<b>REFERENCE:</b>	<b>TSB:</b> 18-066-23 <b>GROUP</b> 18 - Vehicle Performance	<b>Date:</b>	May 24, 2023	<b>REVISION:</b>	18-101-22 REV. A
<b>VEHICLES AFFECTED:</b>	<b>2019 (DJ) RAM 2500 Pickup</b> <b>2019 (D2) RAM 3500 Pickup</b> <b>This bulletin applies to vehicles equipped with a 6.7L I6 Cummins Turbo Diesel Engine (Sales Code ETL) or a 6.7L I6 Cummins HO Turbo Diesel Engine (Sales Code ETM).</b>			<b>MARKET APPLICABILITY:</b> <input checked="" type="checkbox"/> NA <input type="checkbox"/> MEA <input type="checkbox"/> SA <input type="checkbox"/> IAP <input type="checkbox"/> EE <input type="checkbox"/> CH	
<b>CUSTOMER SYMPTOM:</b>	<p>Customers may experience a Malfunction Indicator Lamp (MIL) illumination. Upon further investigation the technician may find that one or more of the following Diagnostic Trouble Codes (DTC)s have been set:</p> <ul style="list-style-type: none"> <li>• **P061B-00 - Internal Control Module Torque Calculation Performance.</li> <li>• P0299-00 - Turbocharger Underboost.**</li> <li>• P0461-00 - Fuel Level Sensor 1 Performance.</li> <li>• P0506 - Idle Control System RPM - Lower Than Expected.</li> <li>• P20EE - NOx Catalyst Efficiency Below Threshold.</li> <l

**Fig. 1**  
**CP3.3 Design Pump**

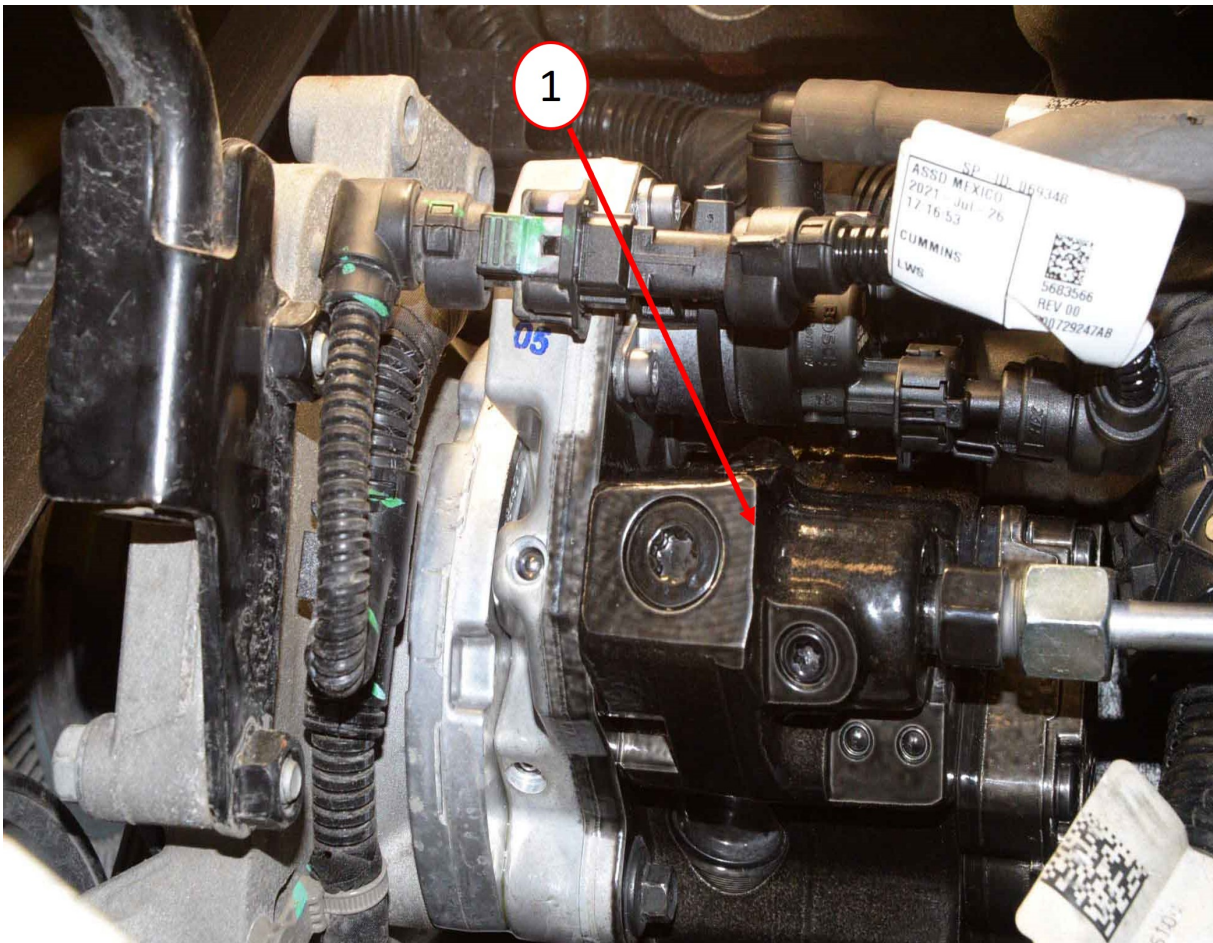
**NOTE: The only calibration available will be for the updated CP3.3 design High-Pressure Fuel Injection Pump (Fig. 1) . Please ensure that recall Y78 has been completed first before proceeding with this update.**

1. Inspect the High-Pressure Fuel Injection Pump to see which pump is currently installed on the vehicle (Fig. 1) . Also review the vehicle VIP report to see if campaign Y78 has been performed.

2. Does the VIP report indicate that Y78 has been performed, and is the vehicle equipped with the new design fuel injection pump released under the campaign?
  - YES>>> Proceed to [Step 1](#).
  - NO>>> Perform the Y78 campaign first. Once the campaign is performed, new pump installed and PCM updated, the PCM will have all of the updates listed in this document. This Bulletin does not apply.
